ADDENDUM NO. 2
to
CONTRACT DOCUMENTS

for
ADDITIONS AND RENOVATIONS
to the
COMMUNITY PARK ELEMENTARY SCHOOL
located at 372 Witherspoon St, Princeton, NJ 08542

for
PRINCETON PUBLIC SCHOOLS
PRINCETON, MERCER COUNTY, NEW JERSEY

Issued: January 23, 2026

2 AREA OF WORK 'AB' - ALT-BID CP-3
1/8" = 1'-0"

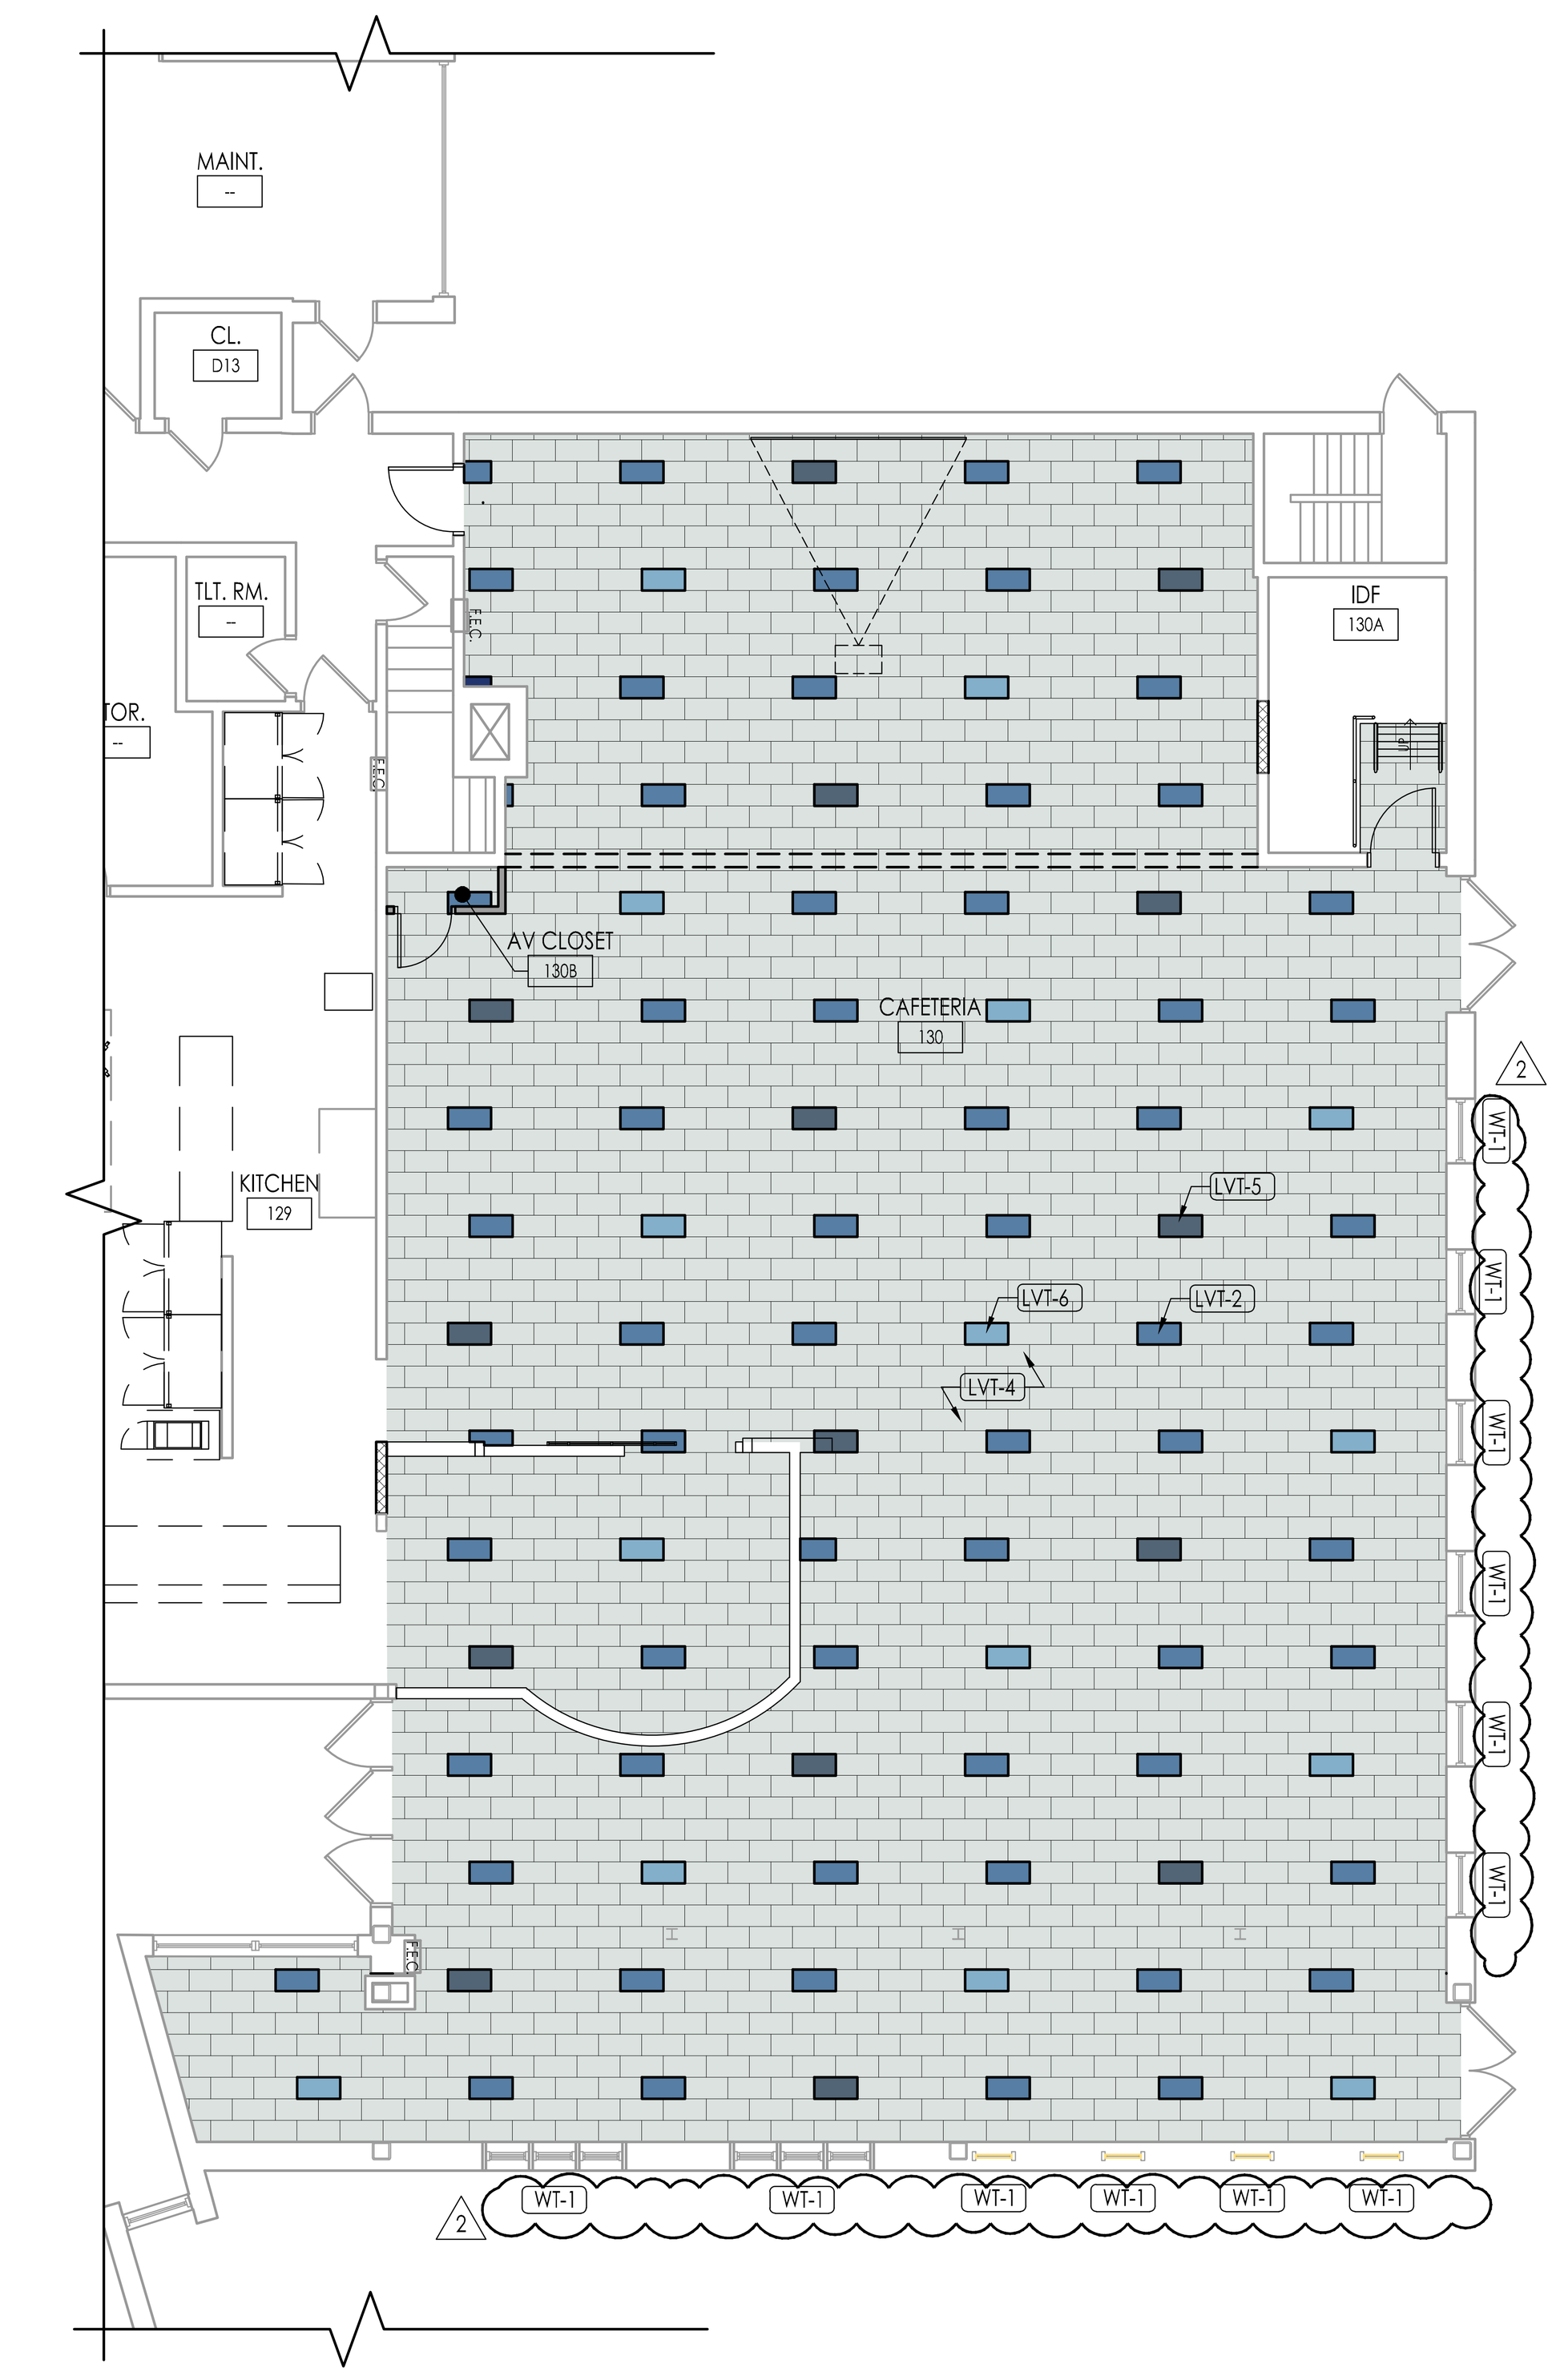
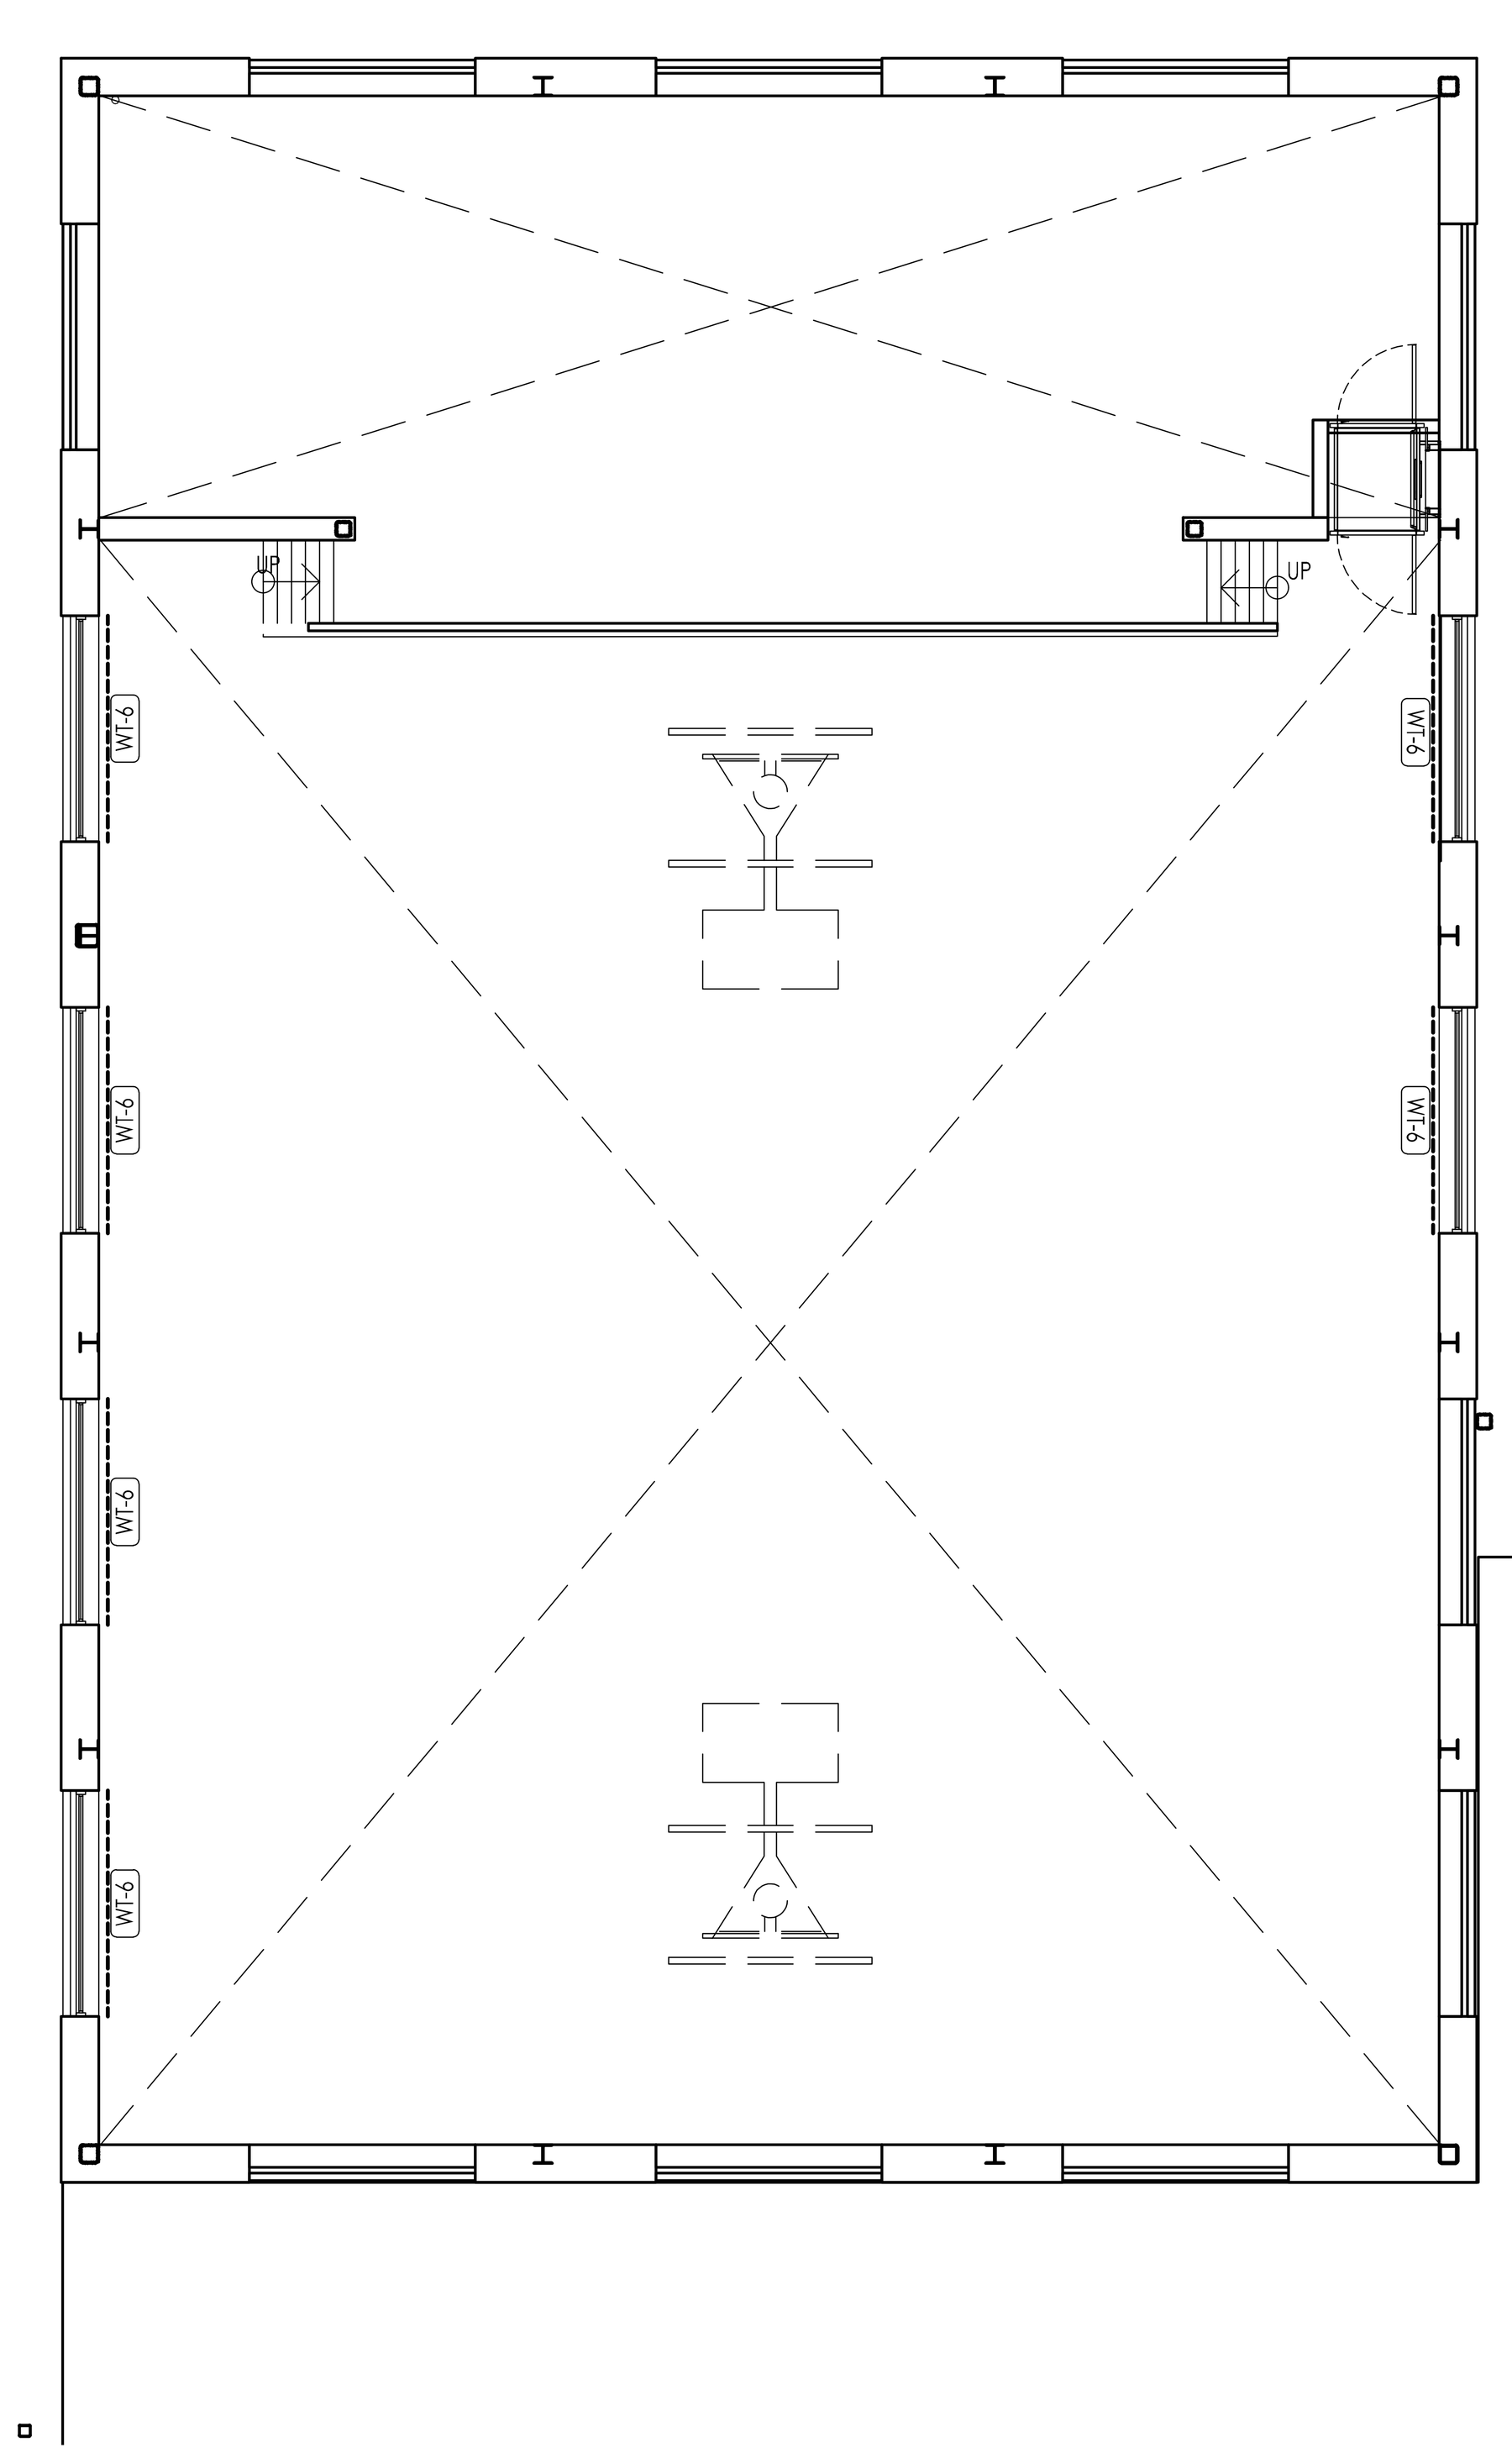
16. Question: On A-702 window treatment callouts are not very visible in dark areas on printed drawings, please move designation to a more visible area and reissue this drawing.

Response: See revised drawings A702 and A703, attached to this Addendum.
